REACTIVITY CONTROL SYSTEMS

3/4.1.5 STANDBY LIQUID CONTROL SYSTEM

Attachment A - Insert to BASES 3/4.1.5

FIGURE 3.15-2

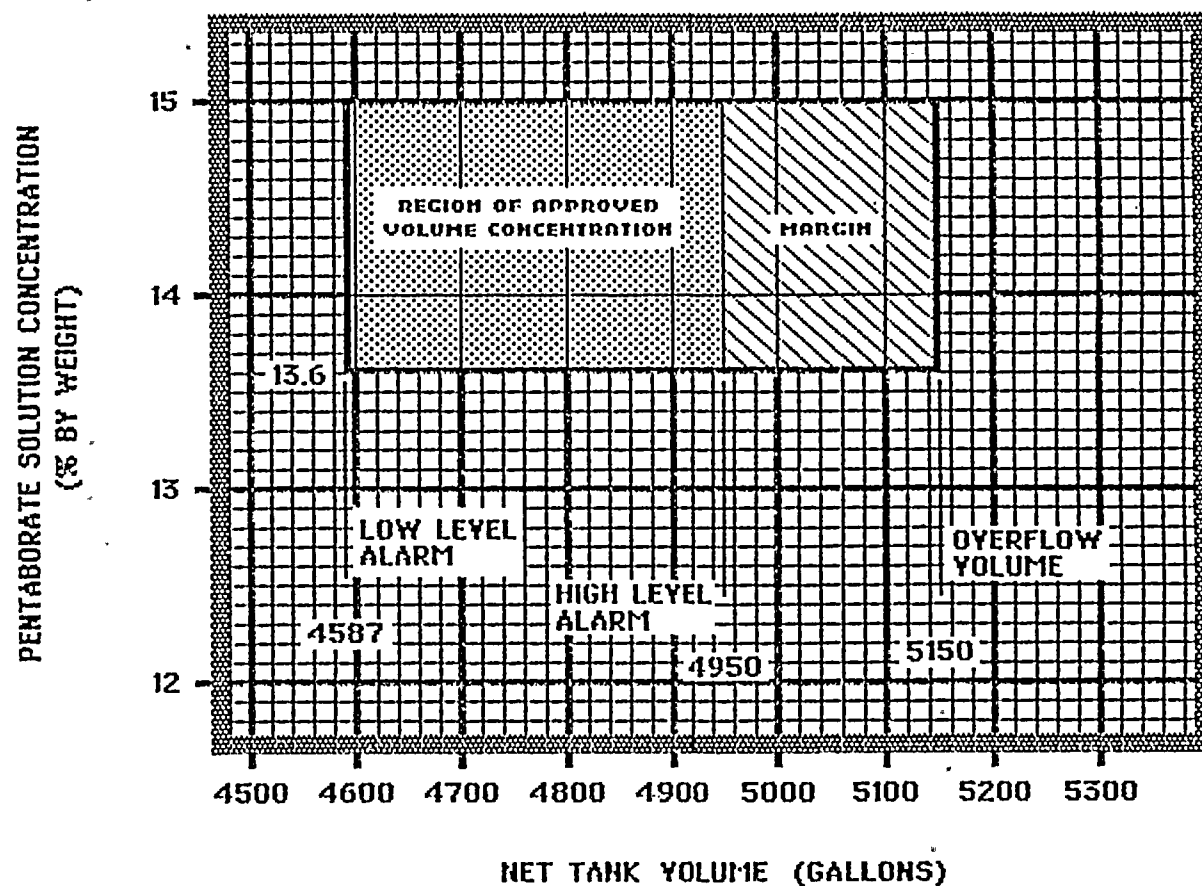
Replaced with
Attached Revision
